SUBJECT: Responds to request for addl info concerning Monticello individual plant exam submittal per Generic Ltr 88-20.

MONTICELLO NUCLEAR GENERATING PLANT
Docket No. 50-263 License No. DPR-22

Response to Request for Additional Information
Concerning the Monticello Individual Plant Examination
(IPE) Submittal - Generic Letter 88-20 (TAC No. M74435)

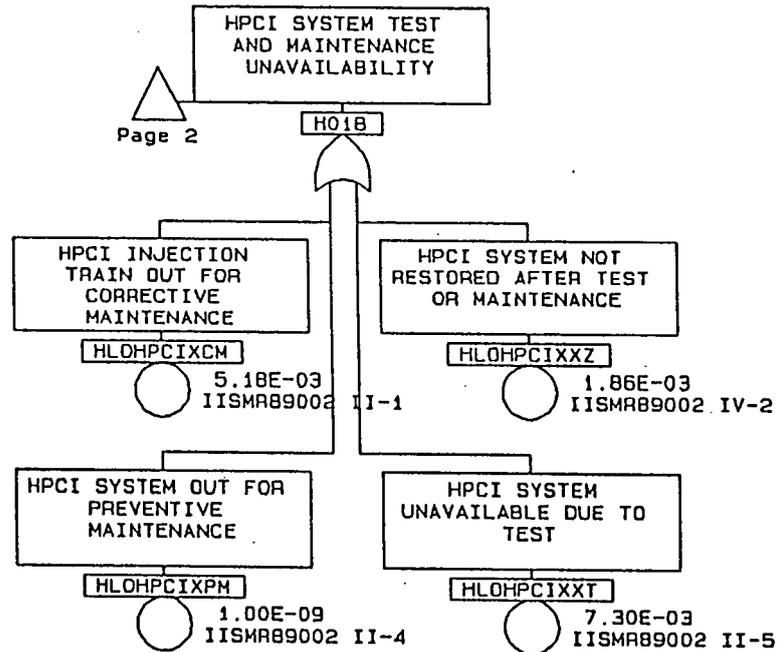
Sections 3.3.4.2 and 3.3.4.3 indicate that maintenance and testing activities are of importance, but no explanation of how these activities were incorporated in the fault trees was provided. Per NUREG-1335 reporting guidelines, describe the method used to calculate unavailability and discuss the impact this has on its contribution to system failure. Discuss the insights into the significance of the contribution to core damage from maintenance/testing activities that NSP has gained from incorporating these activities in the model.

Testing, corrective maintenance, preventive maintenance, and restoration error unavailabilities were included on the fault trees for the plant systems. An example is shown on the next page.

This study reflects Monticello's practice of not performing preventive maintenance on important components with the reactor critical.
